# HANDICAP ACCESSIBILITY IMPROVEMENTS

CAMP SEWATARO

The Horsley Witten Group, Inc. (HW) is pleased to provide the Sudbury Planning Board with this letter report summarizing our third review of the proposed stormwater management and erosion controls proposed at 1 Liberty Ledge (Camp Sewataro) as part of its handicap accessibility improvements project. The project includes the construction of three handicap parking spaces and handicap access to the swimming pool area, as well as a paved picnic area adjacent to the pool area. The Applicant has proposed a bioretention system to mitigate the stormwater impacts of the proposed improvements. Two additional accessible parking spaces and a paved pathway are also proposed but no stormwater controls have been shown.

**C101**

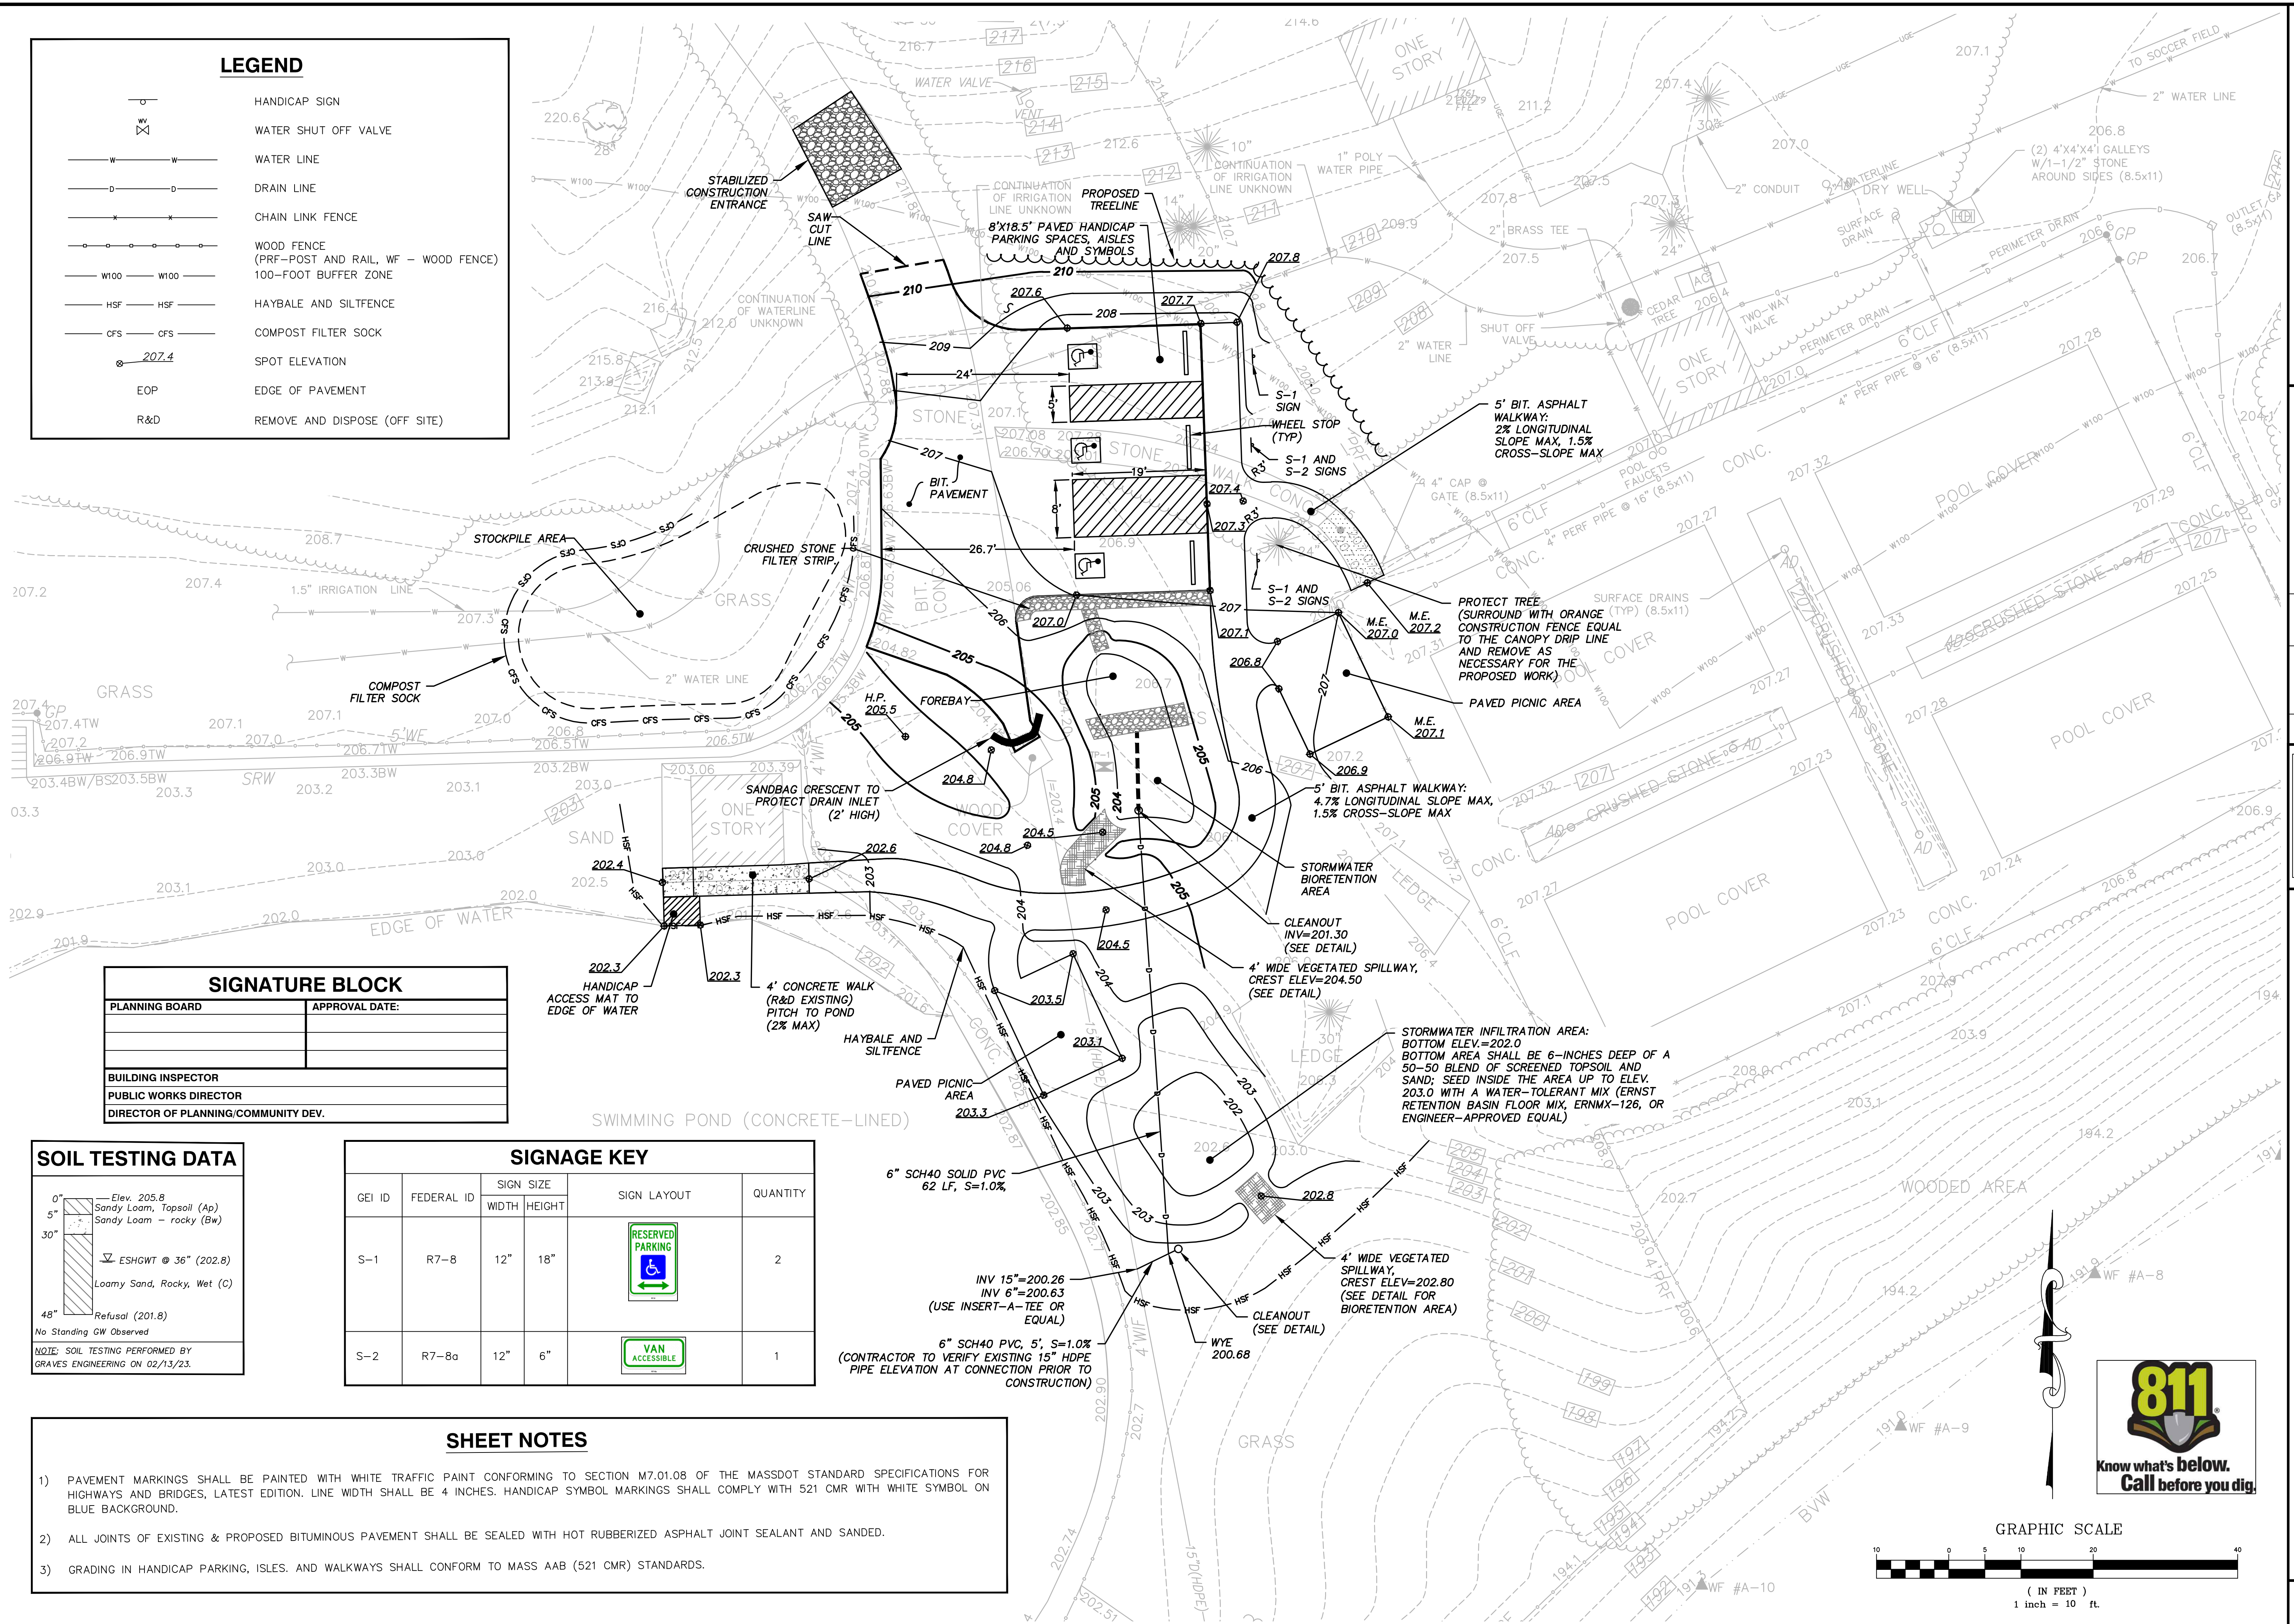
- a. HW recommends that the Applicant designate a location on the site plans for any soil and materials that may be stockpiled during construction as well as a construction entrance for the Project Area.

- d. HW recommends that the Applicant provide a vehicle tracking pad or construction entrance at the access point to the site per the Sudbury Stormwater Bylaws Section 8.B.6.n.

**June 27, 2023: The Applicant has added a stockpile area to Sheet C101. No further action needed.**

**June 27, 2023: The Applicant has added a stabilized construction entrance to Sheet C101. No further action needed.**
